V2_Grading & Erosion Control Plan_COMMENTS.pdf Markup Summary

PCD File PPR265

ASCENT CHURCH

Know what's below.
Call before you dig.

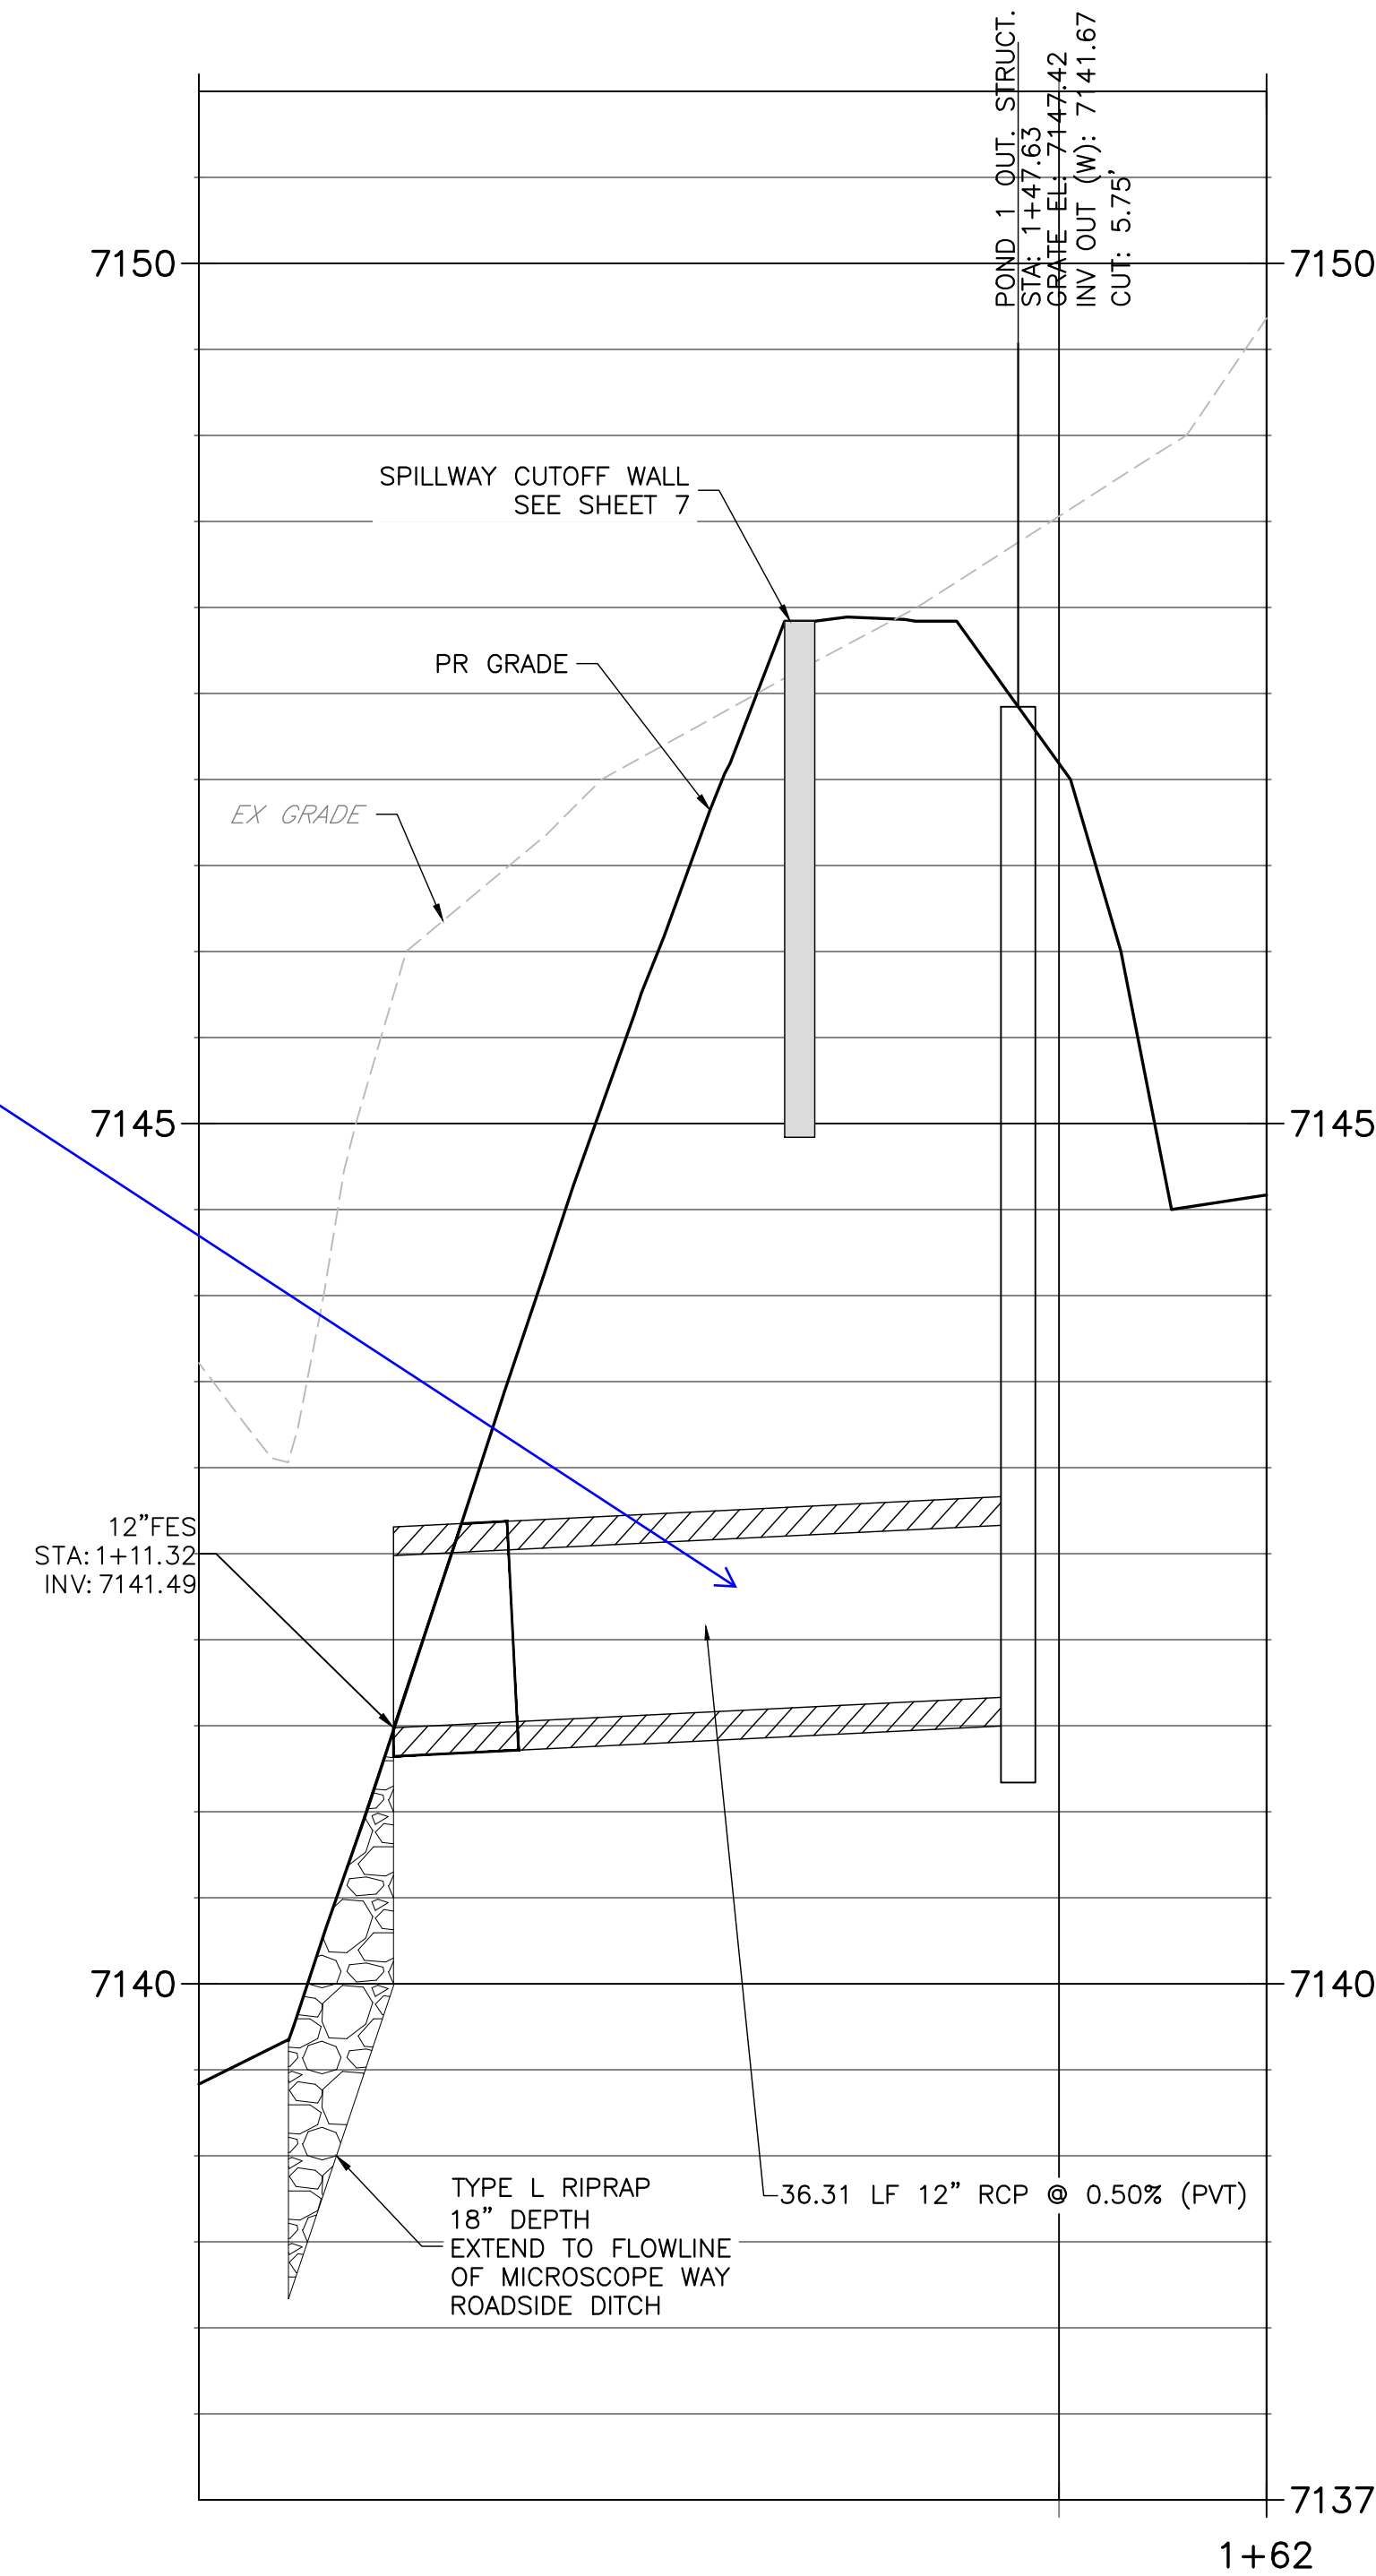
add HGL

JOB NO: 25023 LOCATION: EPC
ASSENT CHURCH
LOW TAILWATER BASIN DETAILS

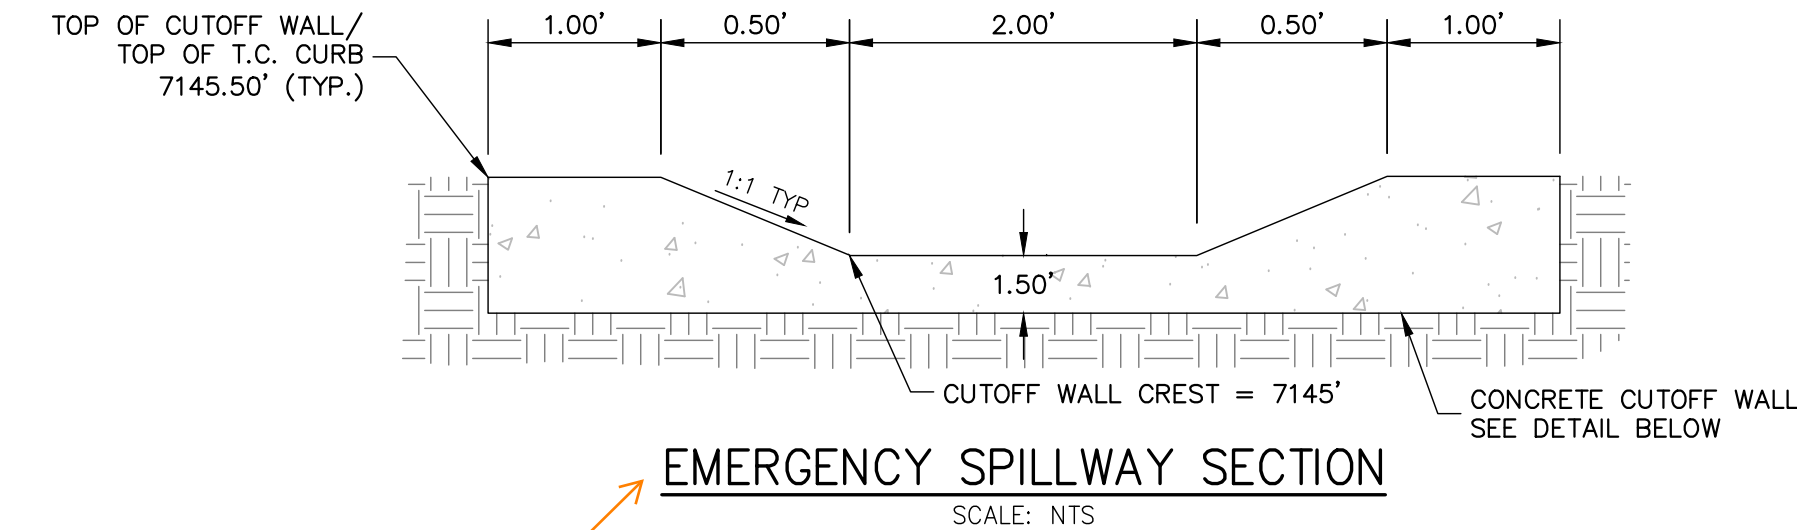
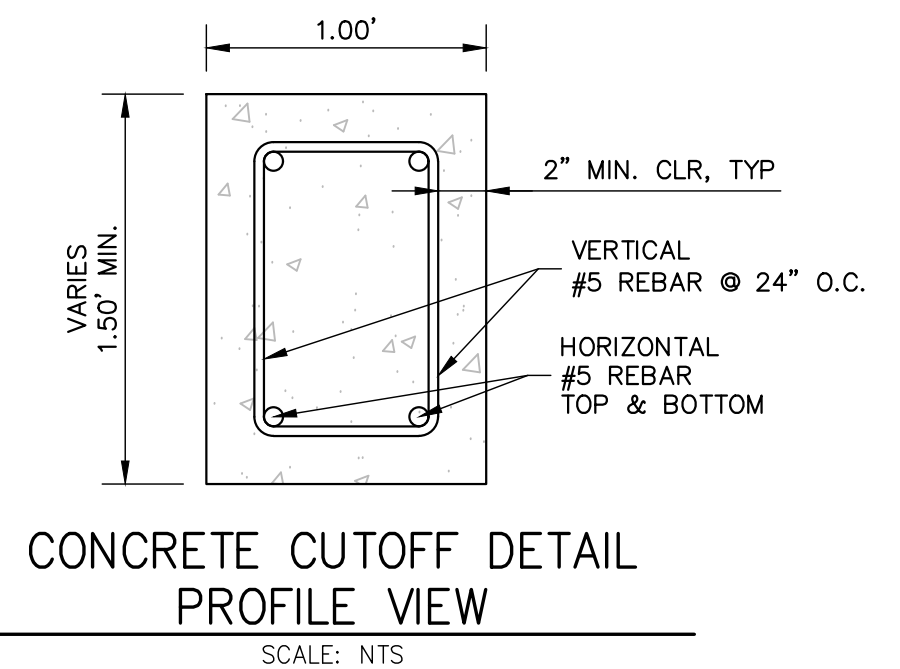
Is this meant to be the typical cross-section of the inflow swale? or will there be a cutoff wall for the swale?
Revise label/detail or remove.

Drainage report contains forebay notch calcs, is there supposed to be a notch here?
Please clarify.

Forebays are recommended for all concentrated SCM inflow locations per MHFD Detail T-6. For smaller tributary areas a concrete pad with a vegetated berm and pipe are acceptable.
